PARTS & SERVICE NEWS

REF NO. AA00195

SUBJECT: FUEL QUICK FILL

APPLICATION: WA700-3L Wheel Loader, S/N A50001 thru A50012

FIGURE 1

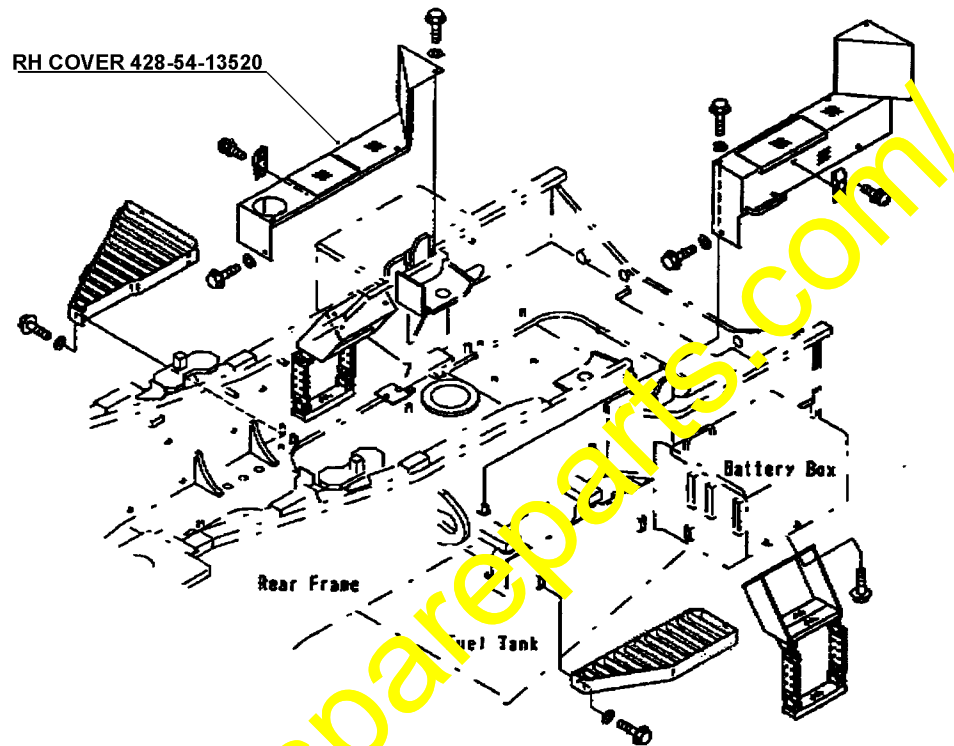
Remove the RH cover (428-54-13520) and set aside for re-use. See Figure 1.

FIGURE 2

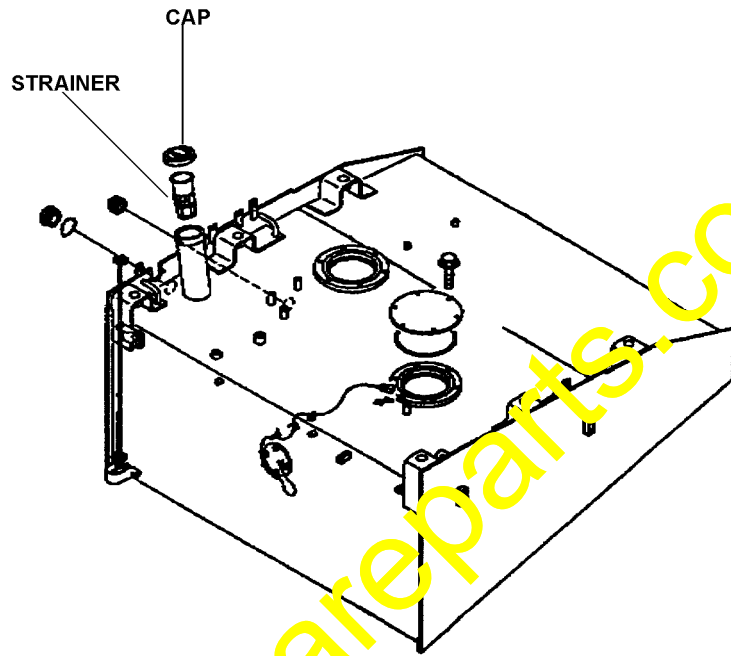
Remove cap (423-04-11362) and strainer (07056-18416). Discard cap and set strainer aside for re-use. See Figure 2.

FIGURE 3

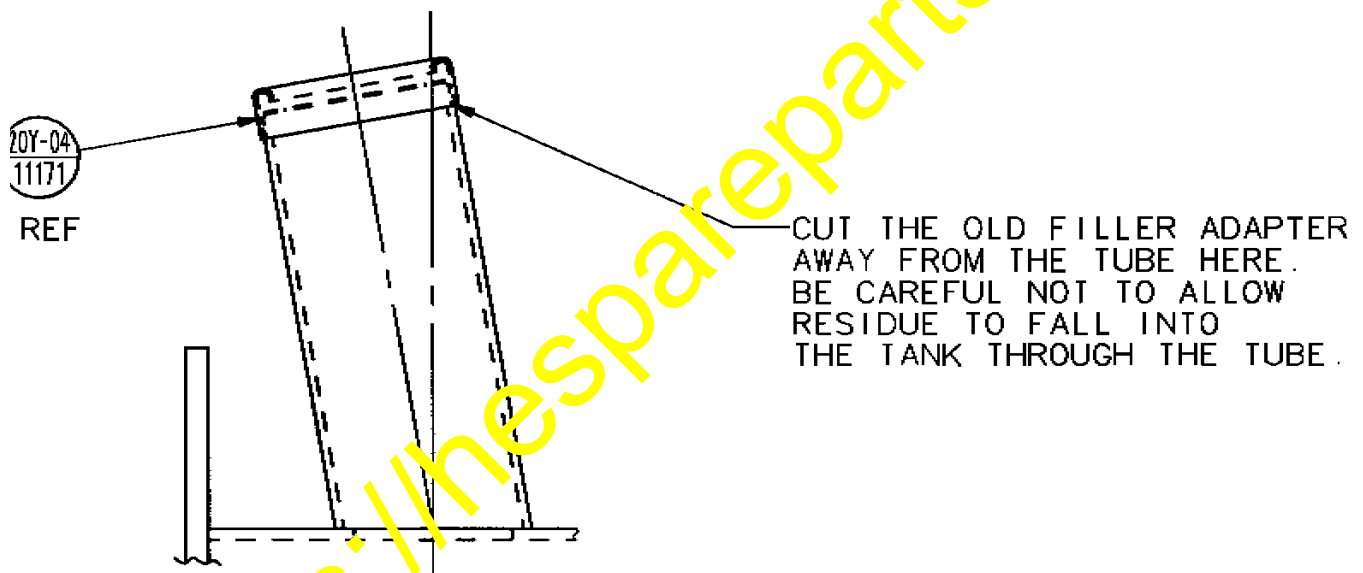
Remove existing filler neck adapter. See Figure 3.

REMOVE EXISTING FILLER NECK ADAPTER
BY CUTTING IT AWAY

FIGURE 4

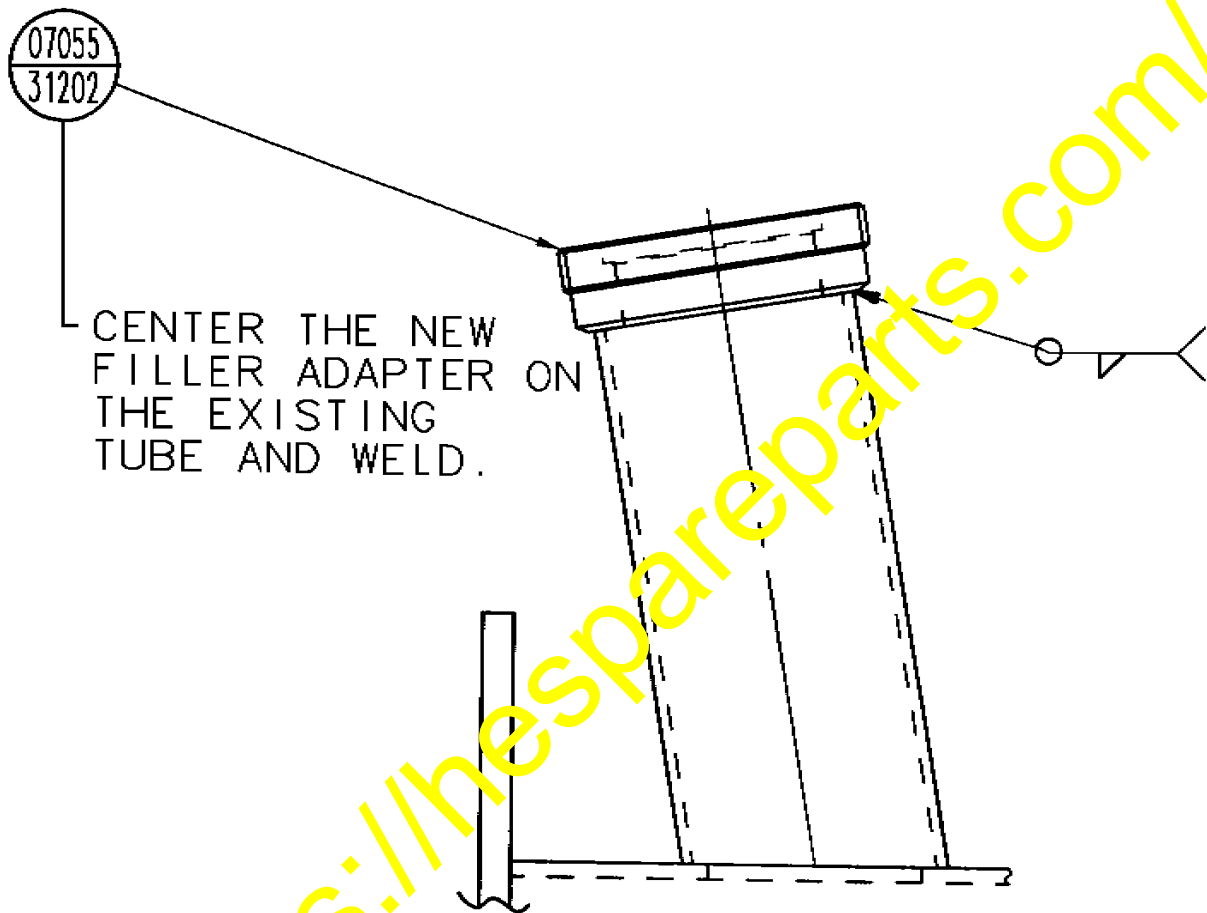
Weld new filler adapter in place and replace strainer. See Figure 4.

Reinstall the strainer removed previously. Install cap (421-04-11260). Install RH cover (428-54-13520)
